Response to reviewers for EGUSPHERE-2024-2925 (*The ZiCOS-M CO₂ sensor network: measurement performance and CO₂ variability across Zürich*)

December 14, 2024

Figure 1: Sensitivity of CO₂ measurement error when the frequency of reference gas cylinder tests and number of days the calibration coefficients were smoothed during parallel measurements for a single sensor.

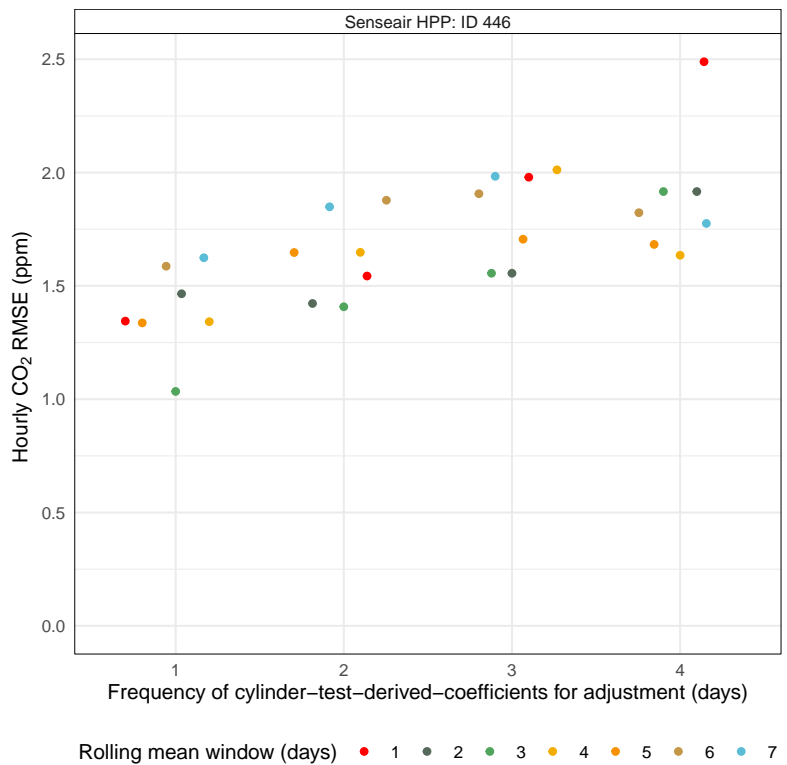
1. Line 228–230: It would be useful to confirm that a longer smoothing and diurnal variation in the calibration time has no effect on the analysis.

The smoothing approach for the application of the calibration coefficients generated by the reference gas tests was tested thoroughly during the parallel measurements programme. We believe the full analysis of gas test frequency and how to handle the tests' coefficients is outside the scope of the manuscript because it was an internal work package to optimise our sensor operations. However, an example of a sensitivity analysis is below (Figure 1). Figure 1 shows the lowest amount of error was generally found with daily gas tests and a three-day rolling mean being applied to the gas tests' coefficients, thus, these criteria were chosen for the sensor operations.
